MEMORANDUM

re: Response to TAC's Review of the Supplemental Traffic Impact Analysis completed 09.01.20 by Bryant Engineering re: Arlington High School

AHS Driveway and Circulation Diagram

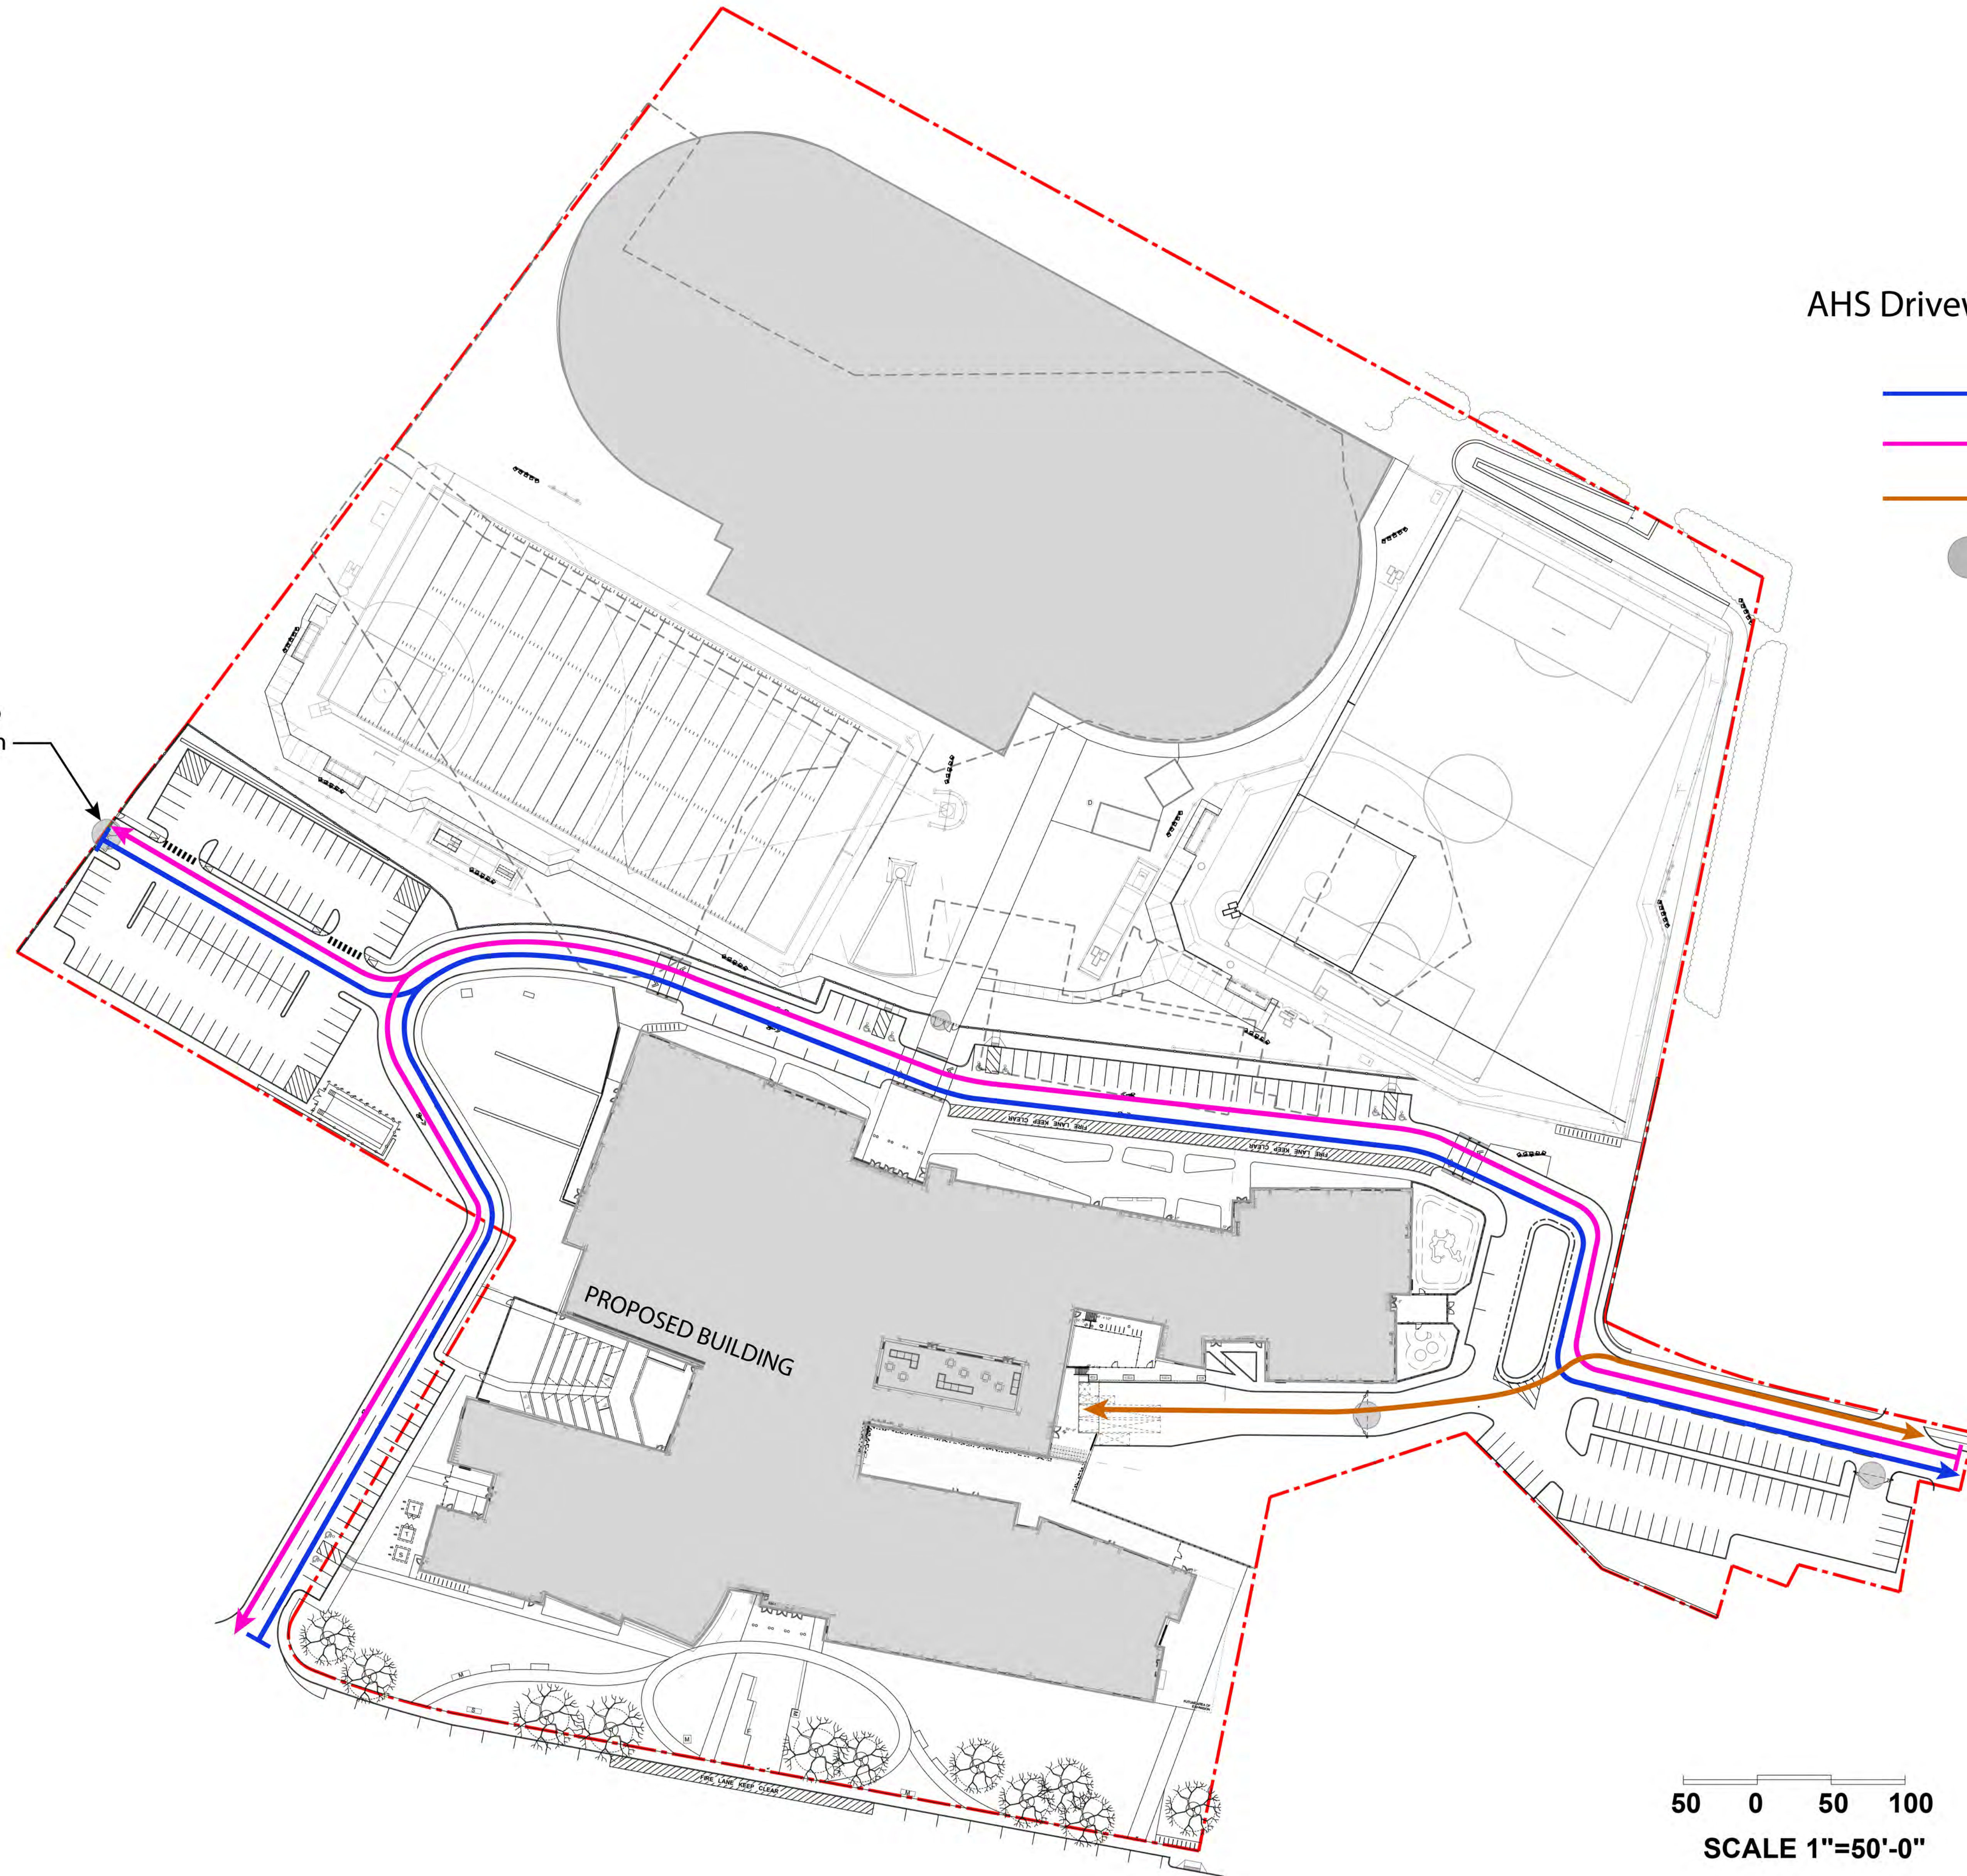
- a) **Clarify the assumptions about how the roadway behind the school would operate in the Build condition.**

See attached site plan diagram titled "Circulation on Driveway".

Vehicular Gate to Control Circulation
